Project	IEEE 802.16 Broadband Wireless Access Working Group < http://ieee802.org/16 >	
Title	Clarification on STC Encoding for MIMO OFDMA	
Date Submitted	2004-11-04	
Source(s)	<p>Wonil Roh, JeongTae Oh, Chan-Byoung Chae, Kyunbyoung Ko, Hongsil Jeong, Sung-Ryul Yun, Seungjoo Maeng, Jaeho Jeon, Jaeyeol Kim, Soonyoung Yoon</p> <p>Samsung Electronics Co., Ltd.</p> <p>Young-Ho Jung, Seung Hoon Nam , Jaehak Chung, Yungsoo Kim, Sung-Jin Kim, Hojin Kim</p> <p>Samsung Advanced Institute of Technology</p>	<p>wonil.roh@samsung.com</p> <p>Voice: +82-31-279-3868</p>
Re:		
Abstract	MIMO Operation Scenario for OFDMA	
Purpose	Adoption of proposed changes into P802.16e	
	Crossed-out indicates deleted text , <u>underlined blue indicates new text change to the Standard</u>	
Notice	This document has been prepared to assist IEEE 802.16. It is offered as a basis for discussion and is not binding on the contributing individual(s) or organization(s). The material in this document is subject to change in form and content after further study. The contributor(s) reserve(s) the right to add, amend or withdraw material contained herein.

Clarification on STC Encoding for MIMO OFDMA

Figure aaa Illustration of STC for optional zones in DL (Matrix A for 2,3,4 Tx and Matrix B for 3,4 Tx)

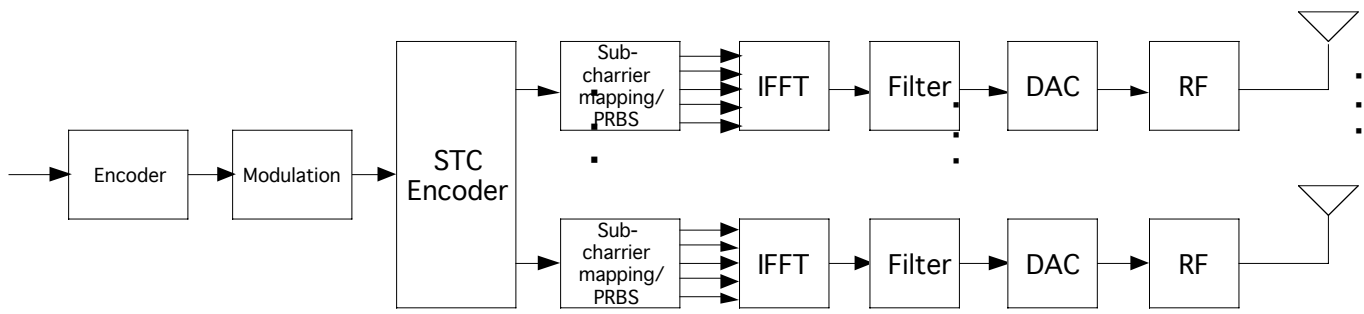
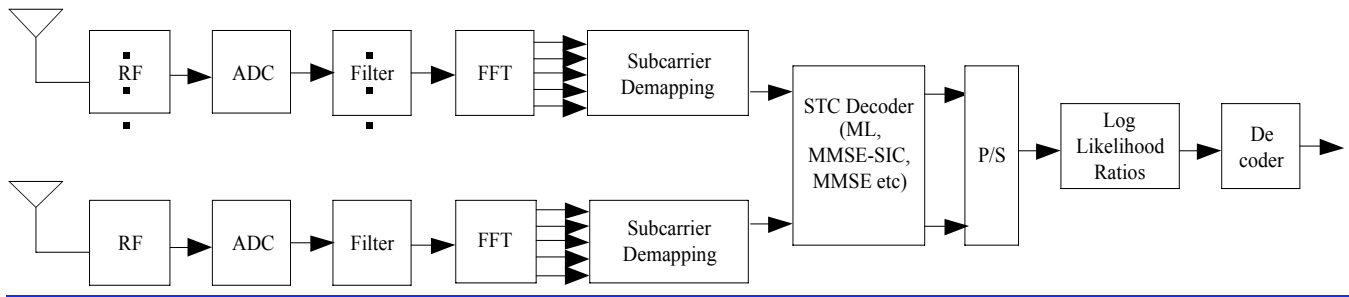
[Replace Figure 232 in page 236 of [1] with the following]

In this Figure the STC encoder operates on input symbols sequentially and distributes the antenna specific symbols to each antenna path. The block of subcarrier mapping and PRBS function denotes data truncation or puncturing, if needed, pilot insertion, IFFT input packing and each subcarrier multiplied by the factor $2 \cdot (1/2 - w_k)$ according to the subcarrier index k in 8.4.9.4.1. The data truncation for CTC or the puncturing for CC encoder shall be required for 3 Tx and 4 Tx BS.

This Figure also represents the usage of matrix B with vertical encoding for 3 or 4 Tx BS.

Figure bbb - Illustration of Matrix B with Horizontal Encoding for 3 or 4 Tx BS for optional zones in DL

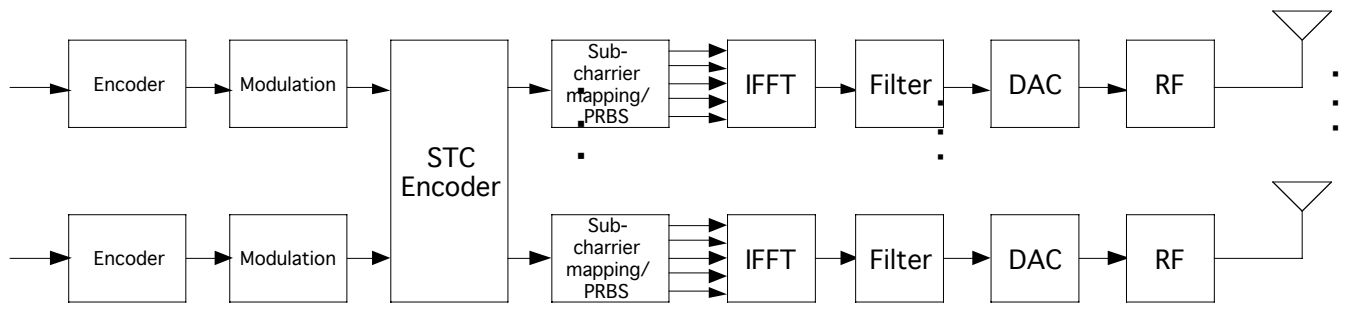
For the usage of matrix B with horizontal encoding for 3 or 4 Tx BS, Figure bbb shall be applied.

Figure ccc - Illustration of Matrix C with Vertical Encoding for 2,3,4 Tx BS for optional zones in DL

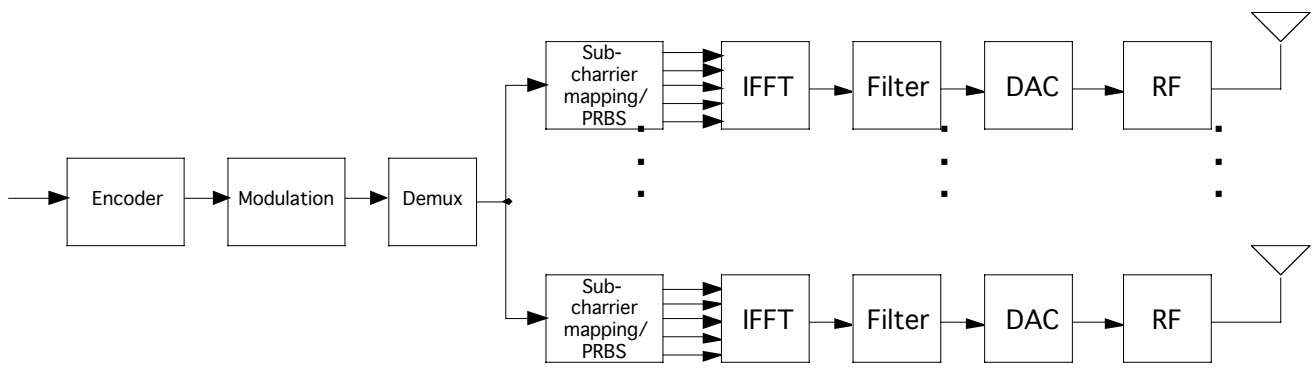
Figure ccc illustrates the usage of matrix C with vertical encoding. The modulated symbols are distributed sequentially from the top to the bottom output paths

Figure ccc - Illustration of Matrix C with Horizontal Encoding for 2,3,4 Tx BS for optional zones in DL

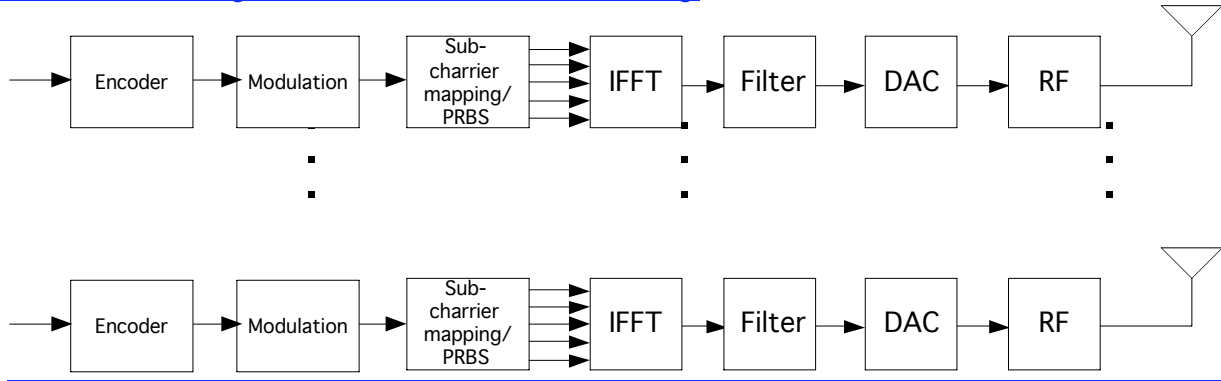
[Figure ddd illustrates the usage of matrix C with horizontal encoding.](#)

Figure bbb - Pilot allocation for 2-antenna BS for the optional FUSC and the optional AMC zones

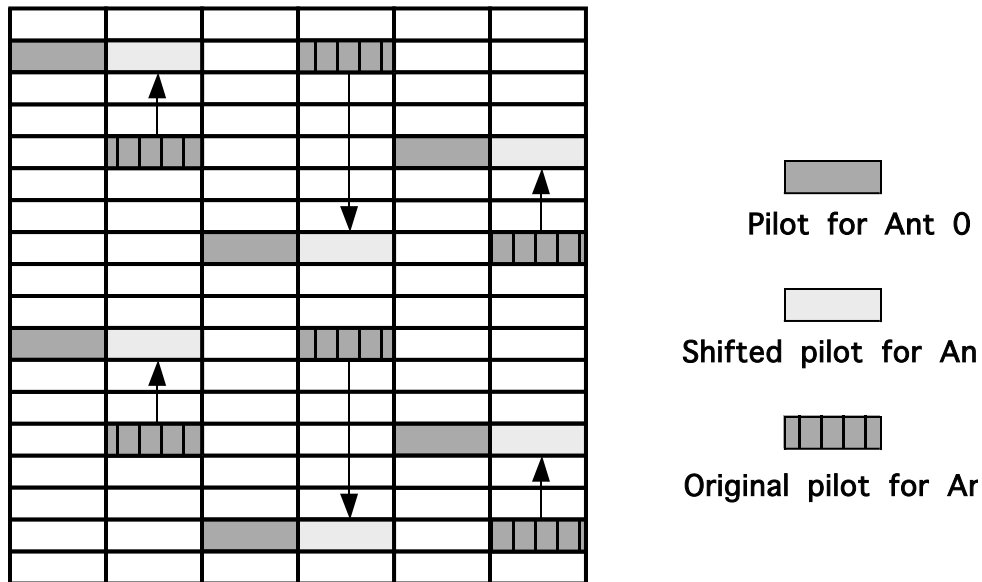
For 2-antenna BS, all pilots in the even symbols shall be allocated for antenna 0 whereas all pilots in the odd symbols shall be allocated for antenna 1. The positions of pilots in the odd symbols are further switched with those of data subcarriers whose locations coincide with pilots in the previous symbol. This is shown in Figure bbb.

Figure ccc - Pilot allocation for 4-antenna BS for the optional FUSC and the optional AMC zones

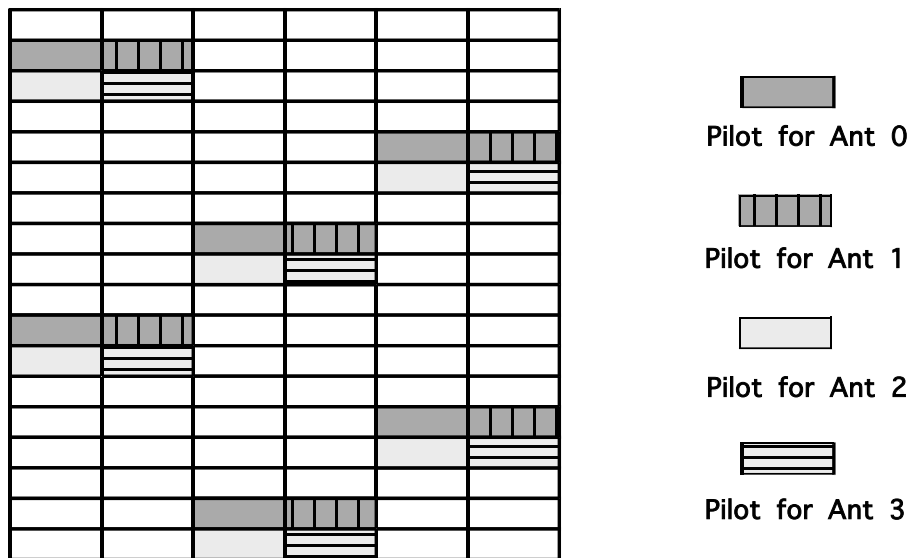
For BS with more than 2 antennas, pilot pattern shall first be changed as in the 2-antenna BS case, and then the neighboring two subcarriers shall be further allocated to pilots for other antennas. Figure ccc shows the pilot allocation scheme for 4-antenna BS.

Figure ddd - Uplink pilot allocation for 2-antenna SS for the optional PUSC zones

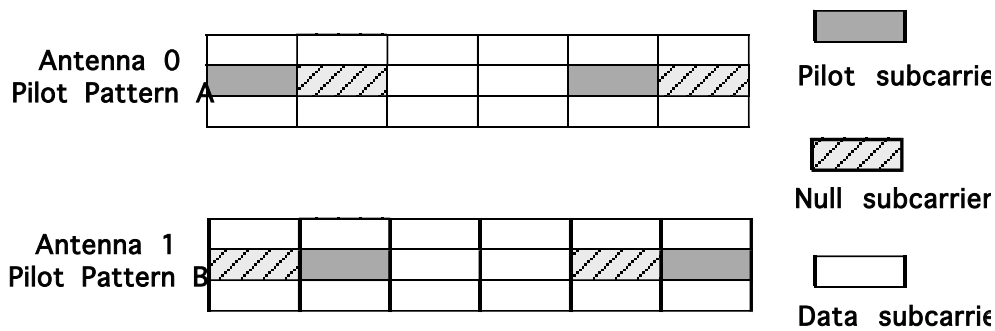
For 2-antenna SS and the optional PUSC, pilots for each antenna shall be allocated as shown in Figure ddd.

Figure eee - Uplink pilot allocation for 2-antenna SS for the optional AMC zones

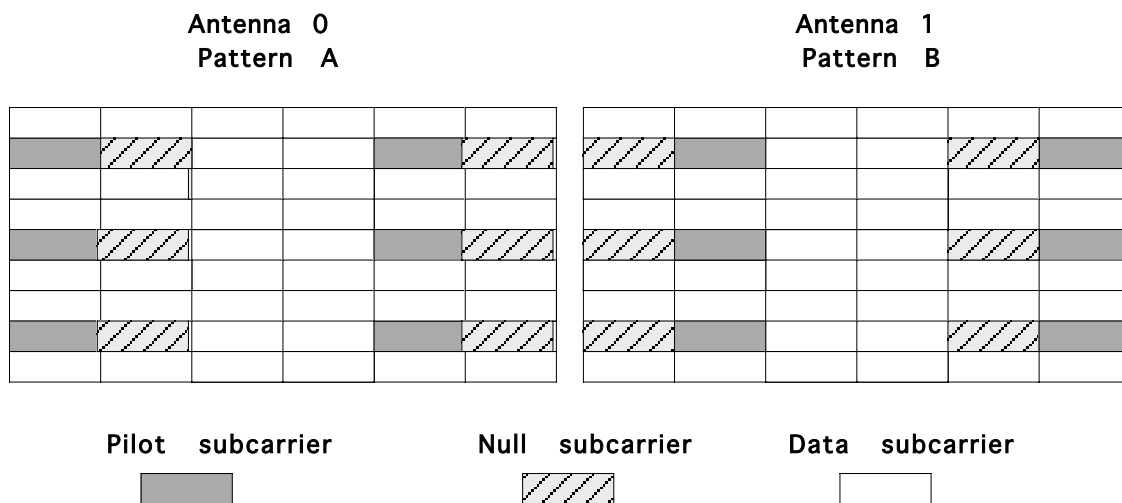
For 2-antenna SS and the optional AMC, all pilots in the 1st, 5th symbols shall be allocated for antenna 0, while pilots in the 2nd and 6th symbols shall be allocated for antenna 1. This is shown in Figure eee.
